**RE: Chase Bank – Indian School Rd.
6670 Indian School Rd. NE
Grading and Drainage Plans
Engineer's Stamp Date: 11/09/20
Hydrology File: J18D001C**

Review Comments

Chase Bank – Indian School Rd.

Grading and Drainage Plan

PLOT DATE
11/05/20
DRAWING SCALE
1" = 10'
PROJECT NUMBER
CDC20013
SHEET NUMBER
C5.01

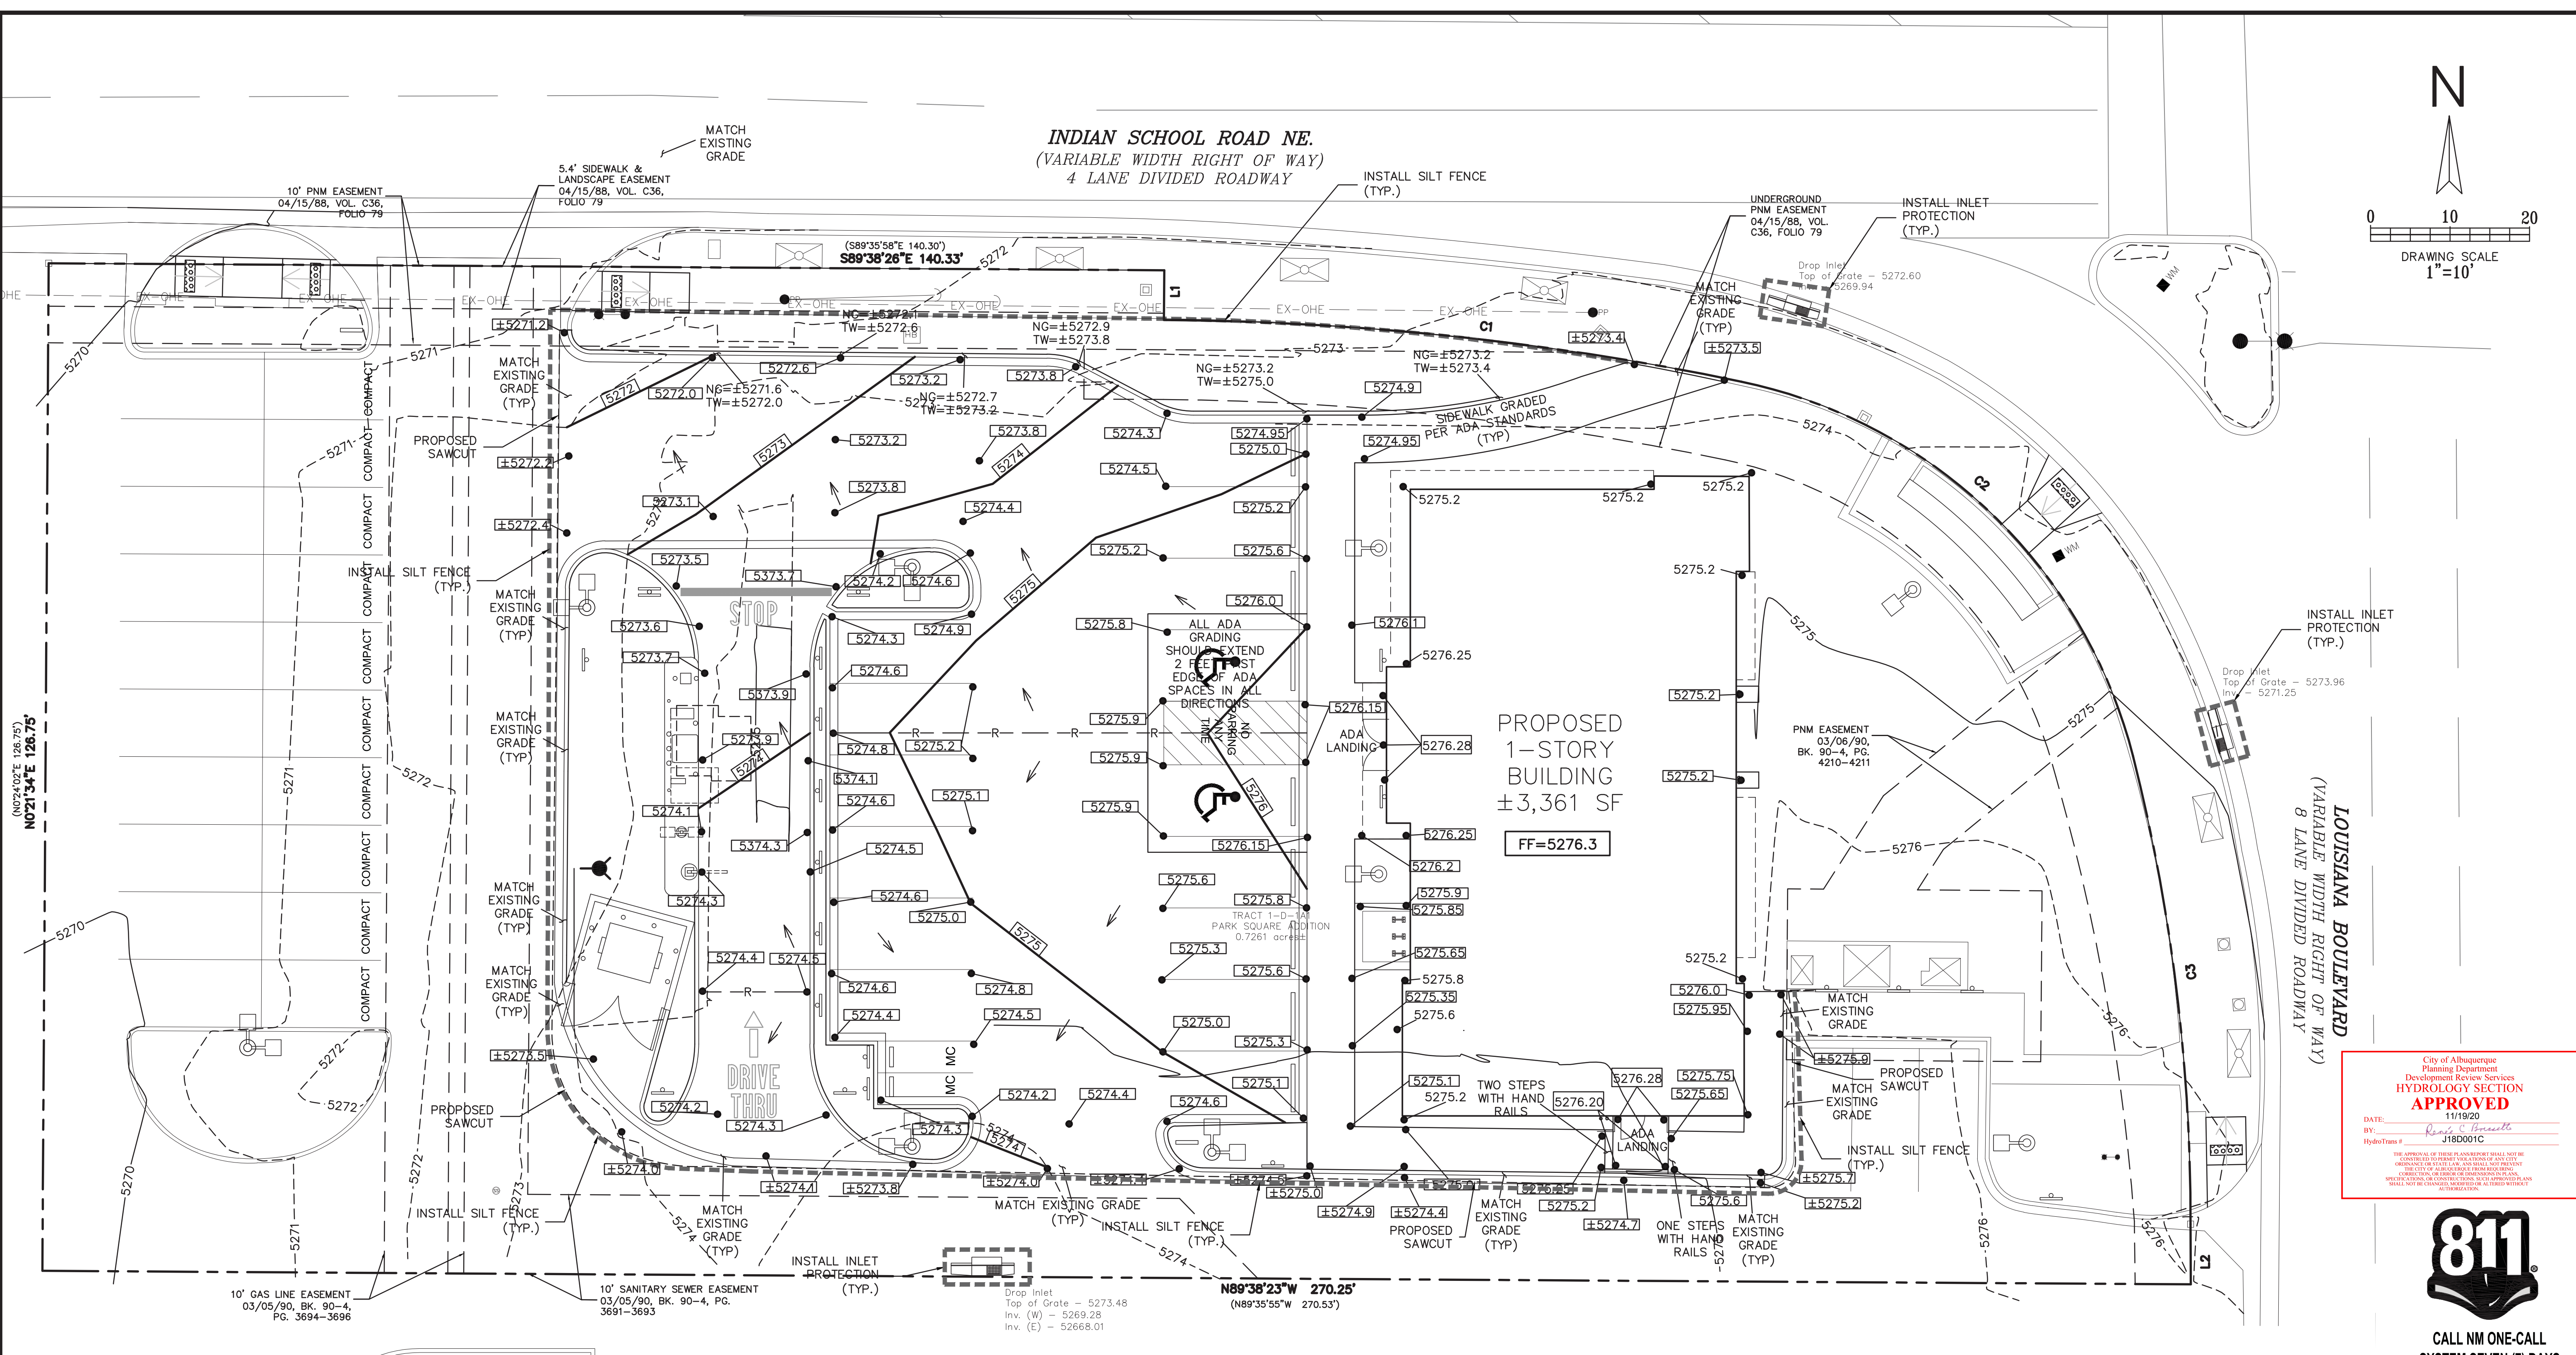
Response: Stormwater Quality Volume calculated. Request Payment-In-Lieu for Public Off-Site Mitigation.
3. Please show the edge of saw cut of the existing pavement and label along this, "Match existing grades". It is currently unclear where the area of construction is starting/stopping.

Response: Saw cut and label added to sheet C5.01.
4. On the Grading Plan, please shade back the existing survey points. It is hard to read what is being proposed.

Response: Existing Survey spot shots removed.
5. As a reminder, if the project total area of disturbance (including the staging area and any work within the adjacent Right-of-Way) is 1 acre or more, then an Erosion and Sediment Control (ESC) Plan and Owner's certified Notice of Intent (NOI) is required to be submitted to the Stormwater Quality Engineer (Doug Hughes, PE, jhughes@cabq.gov, 924-3420) 14 days prior to any earth disturbance.
